GATES PLAZA

UPDATES

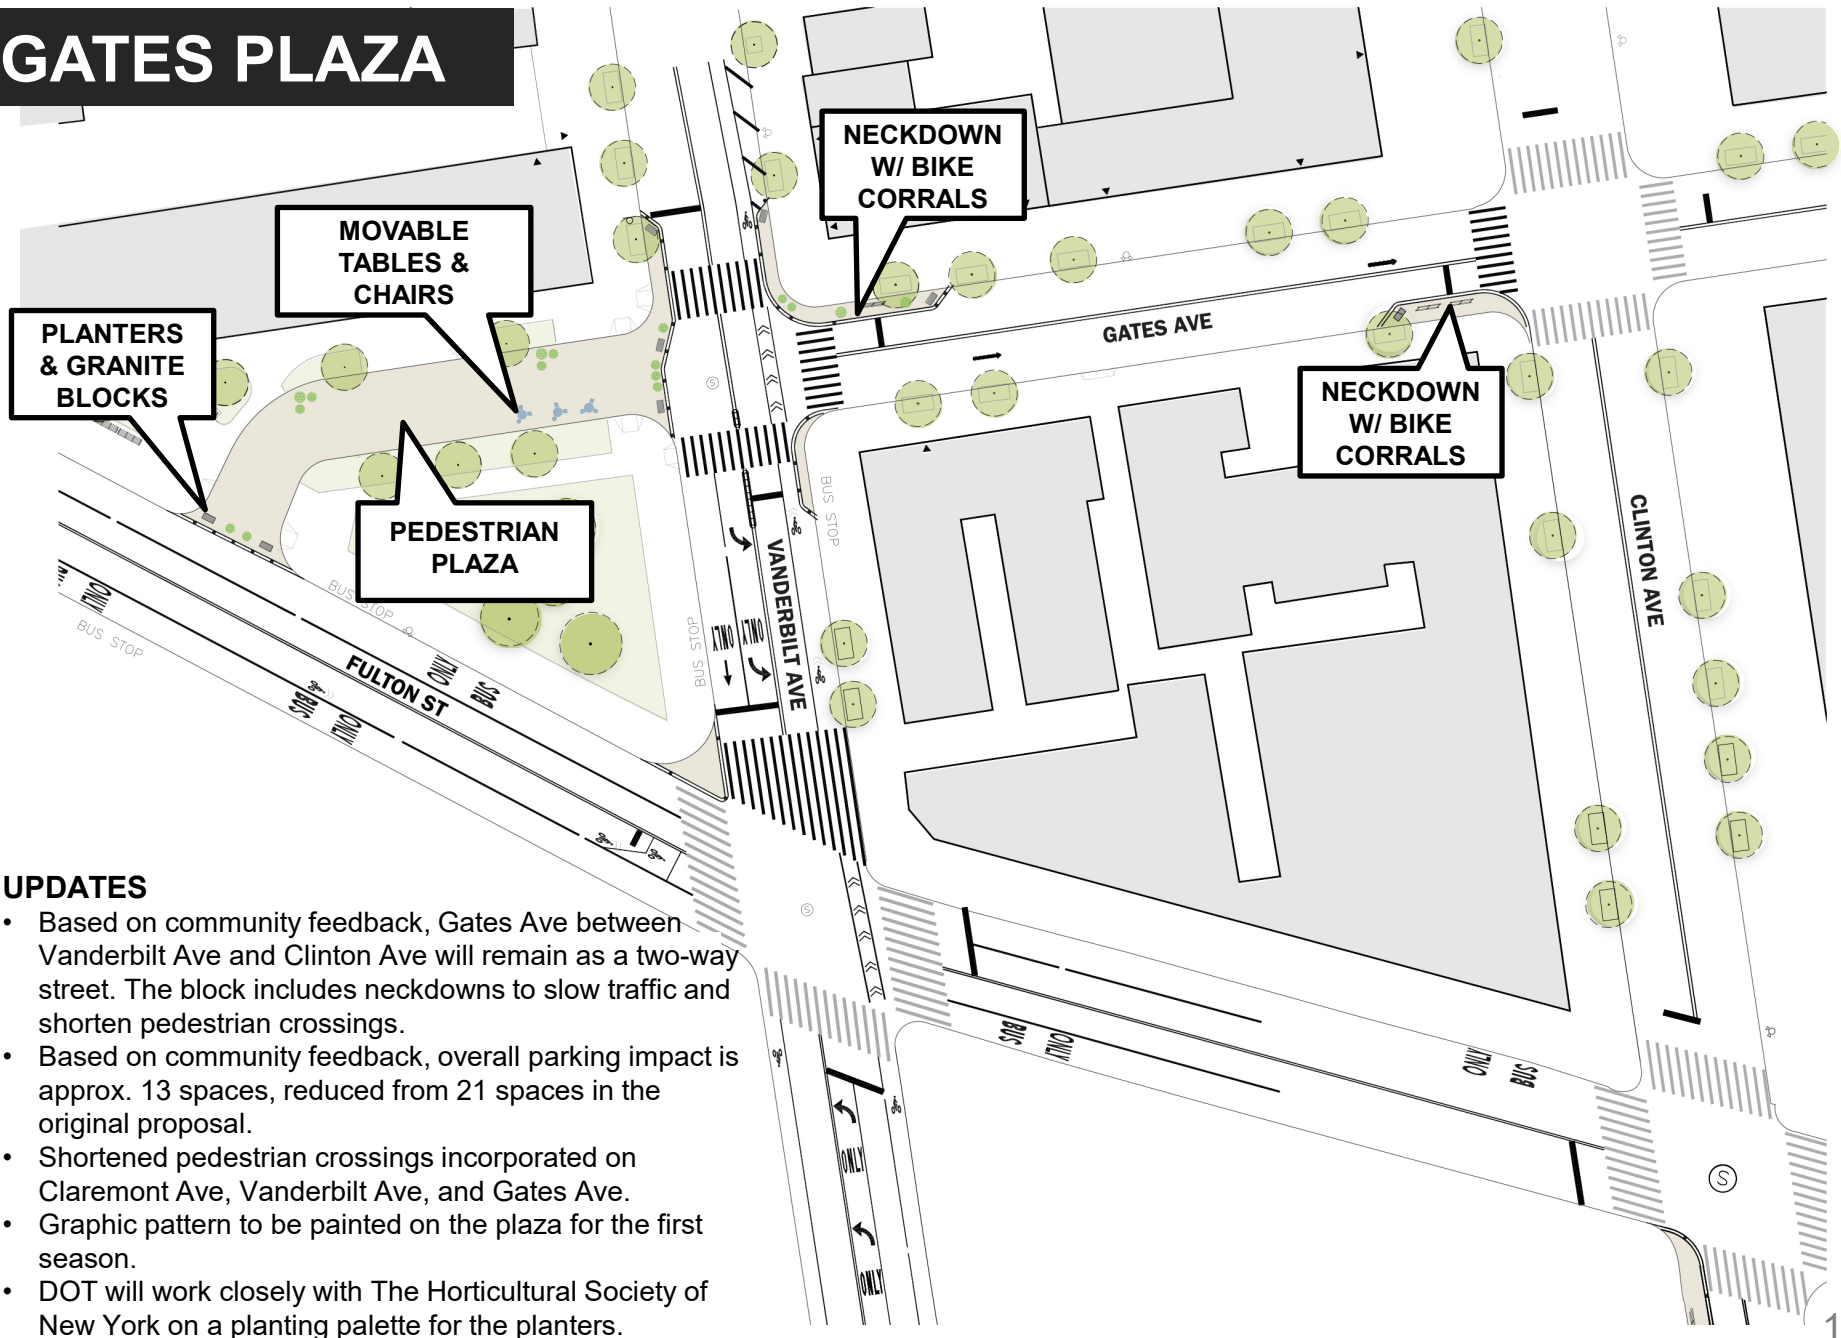
- Based on community feedback, Gates Ave between Vanderbilt Ave and Clinton Ave will remain as a two-way street. The block includes neckdowns to slow traffic and shorten pedestrian crossings.
- Based on community feedback, overall parking impact is approx. 13 spaces, reduced from 21 spaces in the original proposal.
- Shortened pedestrian crossings incorporated on Claremont Ave, Vanderbilt Ave, and Gates Ave.
- Graphic pattern to be painted on the plaza for the first season.
- DOT will work closely with The Horticultural Society of New York on a planting palette for the planters.
